Type of Report: Committee
Council: 3 June 2019
Expiry Date: 20 June 2019
Application No: PLN-19-120
Address: 4 DANVAL PLACE , WEST HOBART
ADJACENT ROAD RESERVE
Applicant: PETER LIDDINGTON
23 SPINNAKER CRESCENT
Proposal: Partial Demolition, Alterations, Extensions and Carport
Representations: Two (2)
Performance criteria: General Residential Zone Development Standards, Parking and Access Code

- 1.1 Planning approval is sought for partial demolition, alterations, extensions and carport at 4 Danval Place, and adjacent Highway Reservation, West Hobart.

Figure 7. Excerpt from submitted plan Drwg No 201 project 1819-12 date 4/3/2019. Red annotations show the A1 standard setback of 4.5m and the 2.9m setback of the existing building.

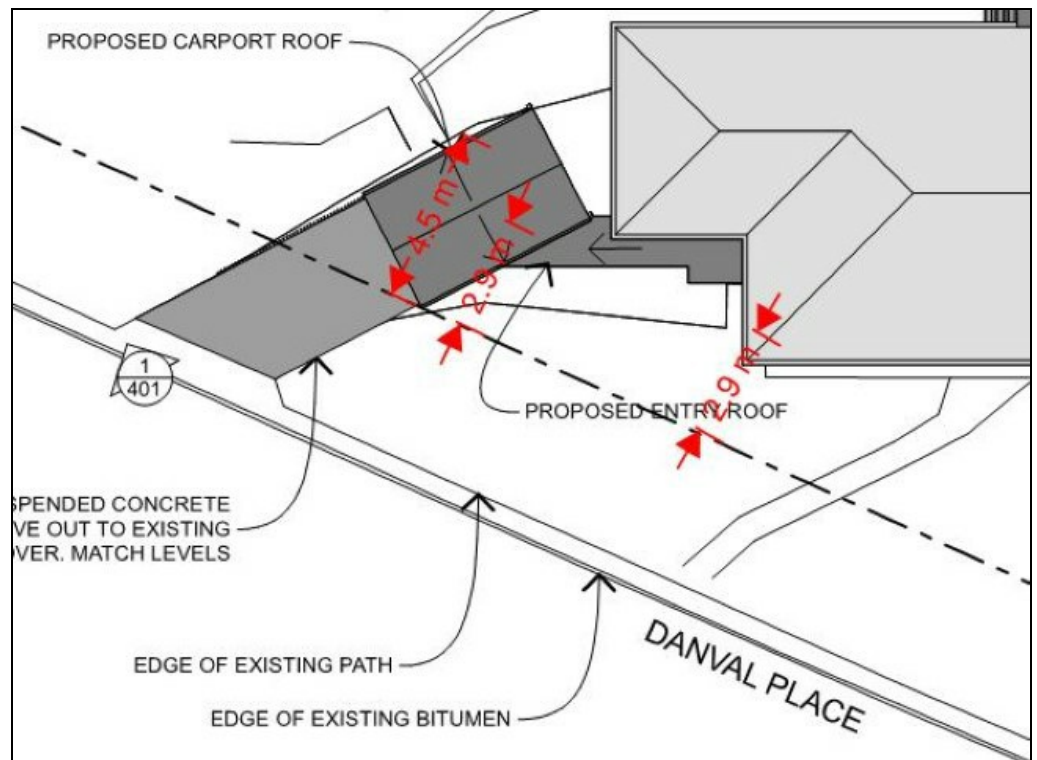
- 6.7.2 The proposal includes a car parking deck and car port with slatted sides - the most forward post of the car port would be on the front boundary, with the building angling away from the frontage. The other post would be 2.5m from the frontage.

The existing dwelling is set on the lot at an angle from the front boundary - the closest distance between a building corner and the frontage is 2.9m.

6.7.3 The proposal does not comply with the acceptable solution; therefore assessment against the performance criterion is relied on.

6.7.5 The car port would introduce a new element to the streetscape not necessarily compatible with the current arrangement - no other car ports are evident in Danval Place. However, it could be argued this is a case of topographical constraint preventing effective use of the existing very steep driveway. As suggested by the representors, this new structure would not

Whilst the design solution offered here is understood - to overcome the driveway gradient issue, the use of the existing cross over, and the limited space between the frontage and the dwelling building, it is considered reasonable to keep the building bulk to a minimum because the car port building is proposed closer than any other building in the street.

Therefore a condition is recommended for the roof design to be made a single plane / skillion, and the timber slats proposed on the north eastern elevation of the car port are to be reduced to be only below the standard balustrade.

1. **The car port roof design must be a single plane/skillion design with a maximum height of no more than 2.7m from the car parking deck level (RL+163 050); and**
2. **The timber slats on the north eastern elevation of the car port must be only below the standard balustrade.**
